How to update T16IZ SUPER

T16IZ SUPER SOFTWARE UPDATE CHANGES

1. Receiver setting : It is now possible to connect a compatible receiver to the S.I/F port of the transmitter and configure the receiver settings.

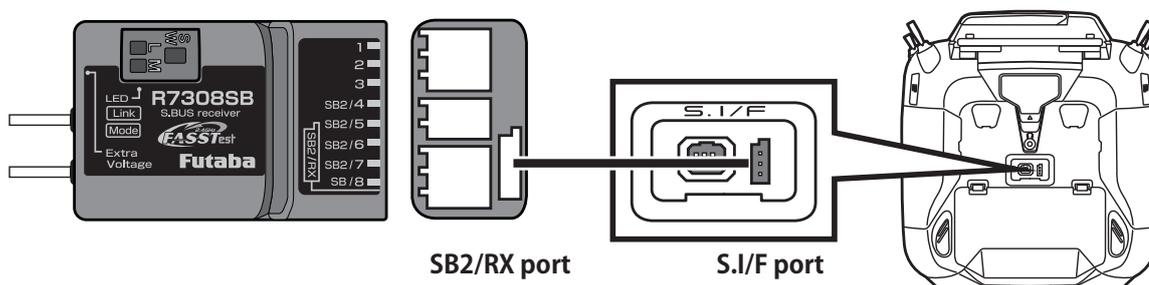
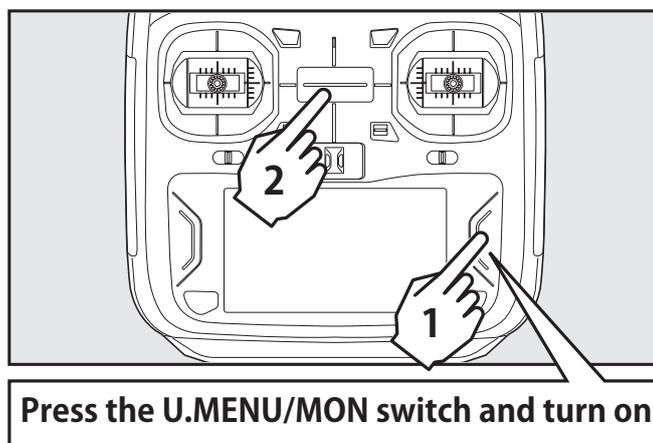
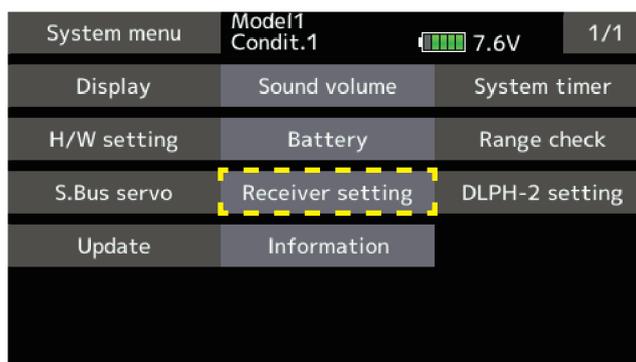
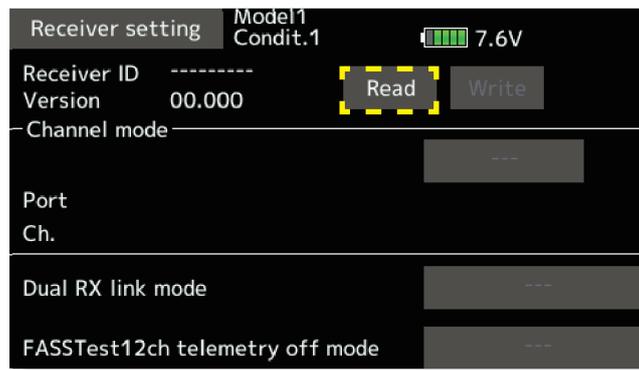
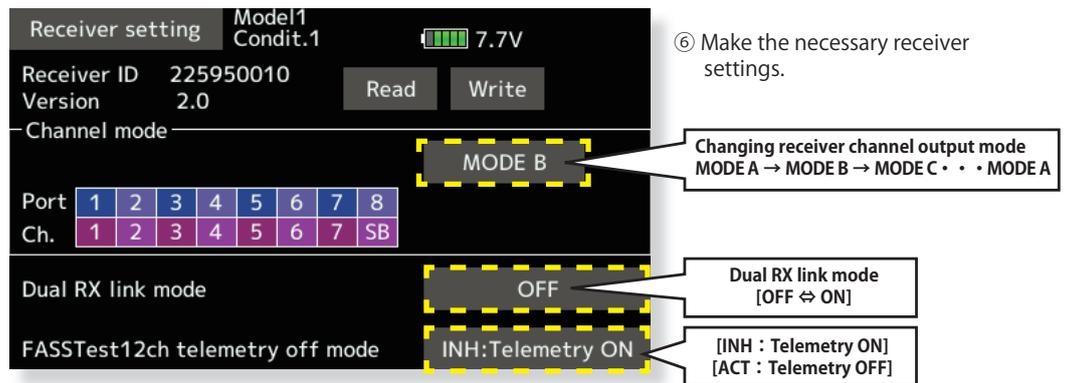
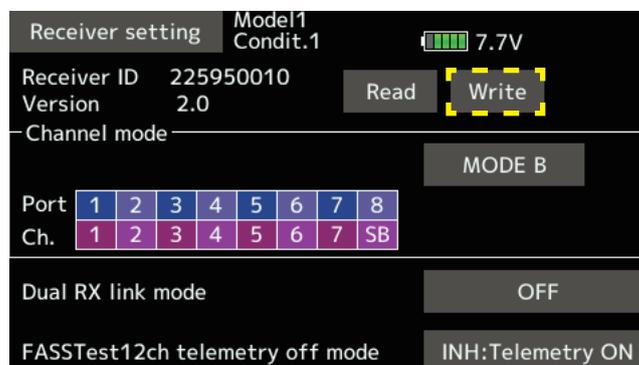
- R7208SB/R7308SB (Compatible with software version 2.0 or later)
- R7206SB/R7306SB
- R7214SB/R7314SB

2. DLPH-2 setting : It is now possible to connect a DLPH-2 to the S.I/F port of the transmitter and configure the DLPH-2 settings.

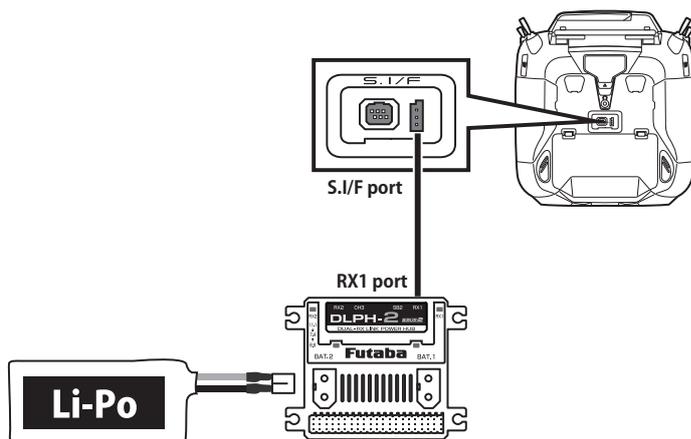
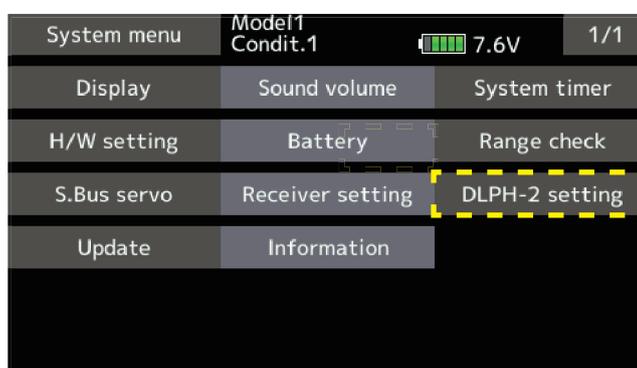
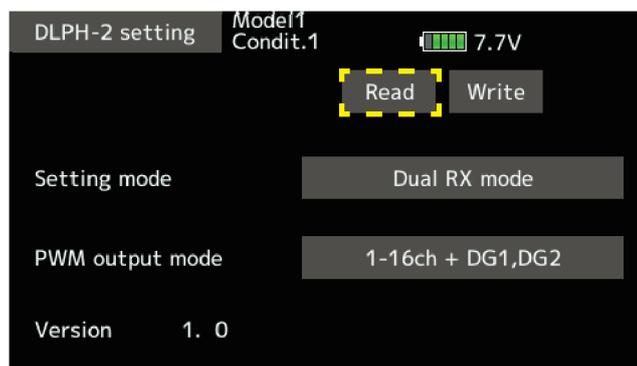
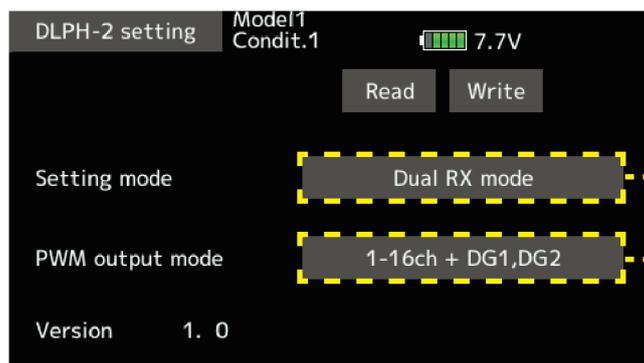
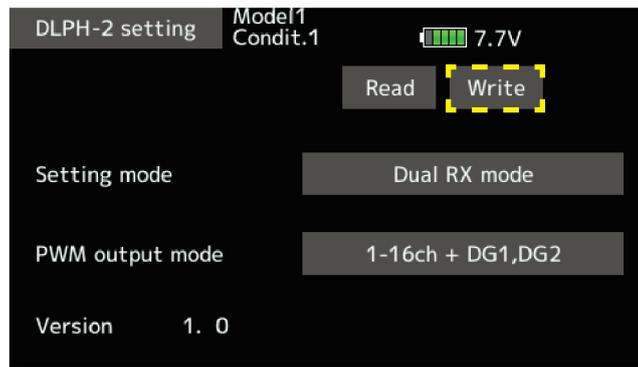
*When setting mode is set to **[Airplane gyro mode]**, PWM output mode is fixed to **[1-16CH + DG1,DG2]**.

1. Switch Sounds : The Sound select function adds sounds to switch positions.

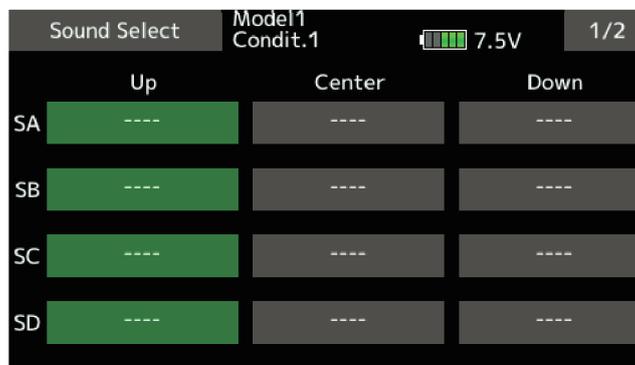
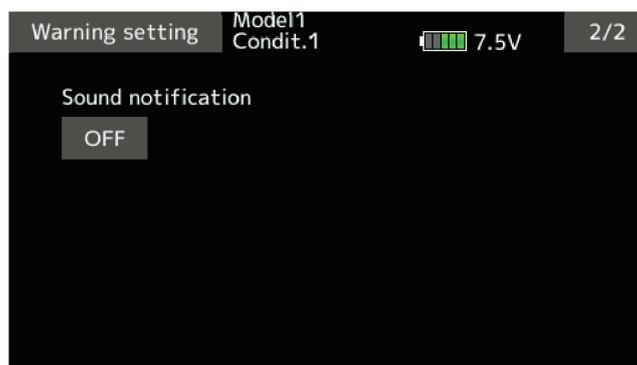
NOTE: Sounds and switch positions do not acknowledge condition priority.

3. Telemetry settings: Added gear ratio setting button to Kontronik ESC and Scorpion ESC.

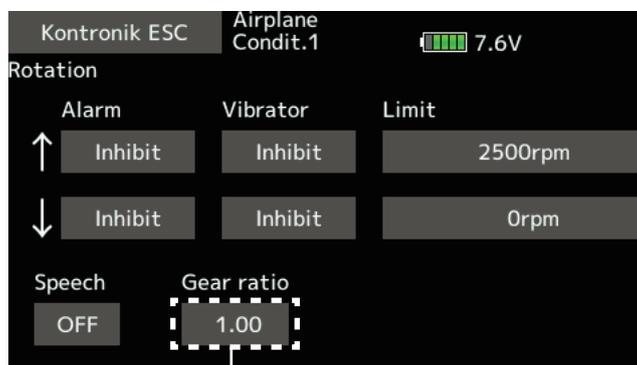
● If the gear is down, enter the gear ratio to display the helicopter rotor speed and the airplane gear down propeller speed.

4. Telemetry settings: Changed the motor pole number setting for each ESC to "100".

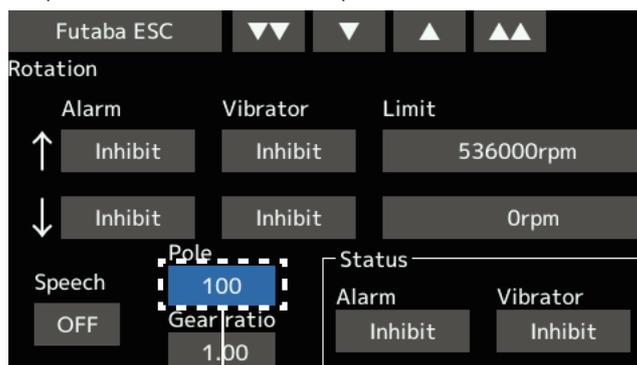
Previously, the number of poles was up to 36, but now it can be set up to 100.

1. Receiver or gyro updates

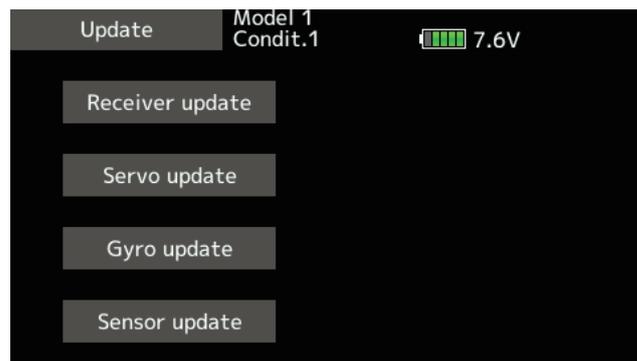
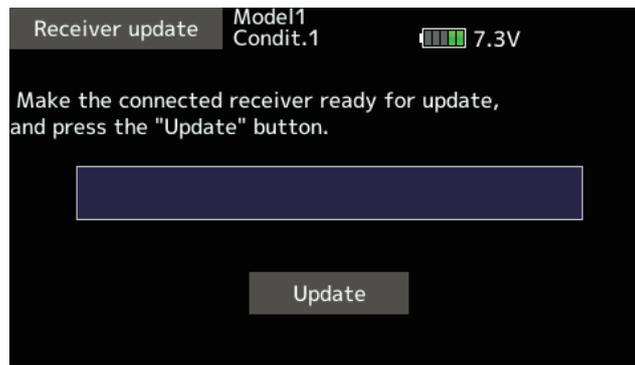
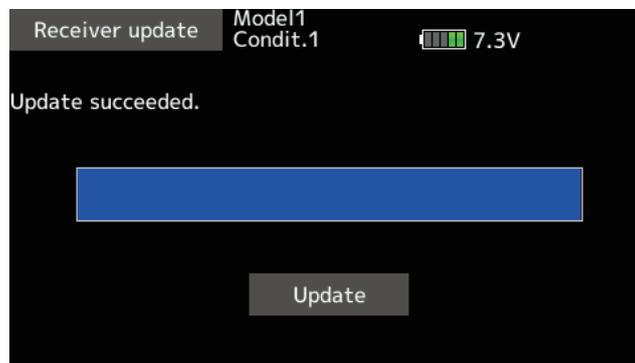
By connecting a receiver or gyro that supports updates to the S.I/F connector of the transmitter, it is possible to update their software.
